Access Compliance Report Public Rights-of-Way (Curb Ramps)

Main Street: HARPER_ST Cross Street: ROOSEVELT_AVE Location: NE

ADA ID: RPRK211001134721 Ramp Type: Type 1 - Perpendicular Diagonal Initial Pass/Fail: Fail Overall Compliance: No Severity Score: 4

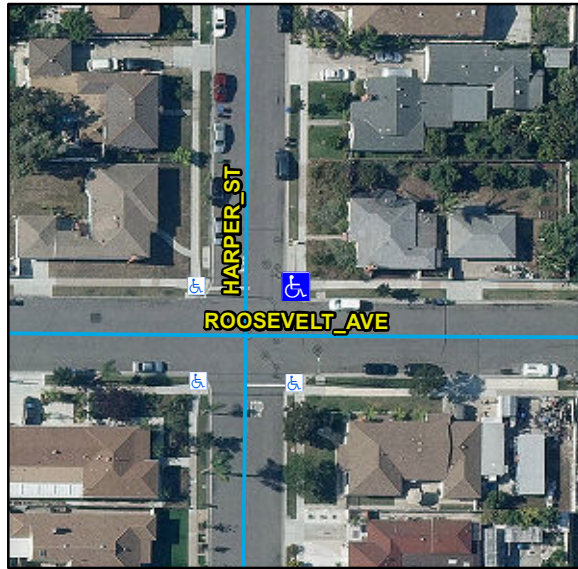
R304.2.2, R304.5.1, STD 1115

Remove & Replace Curb Ramp With Two New Directional Ramps or Equivalent.
